Access Compliance Report Public Rights-of-Way (Curb Ramps)

Main Street: **NARROW_CANYON_RD** Cross Street: **AURA_LN** Location: **SW**

ADA ID: **RPRK211028123801** Ramp Type: **Type 4 - Parallel** Initial Pass/Fail: **Fail** Overall Compliance: **No** Severity Score: **16**

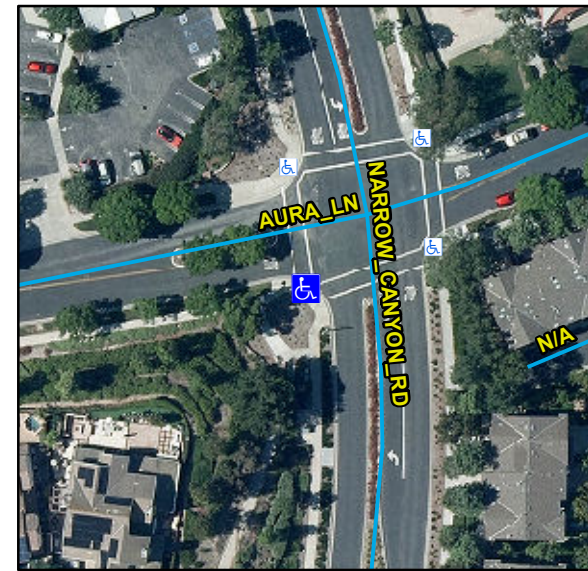
Surveyor Notes:

Possible Solutions:

Remove & Replace Curb Ramp With Two New Directional Ramps or Equivalent.

R204.3, R304.5.3, R304.3.2, STD 1115
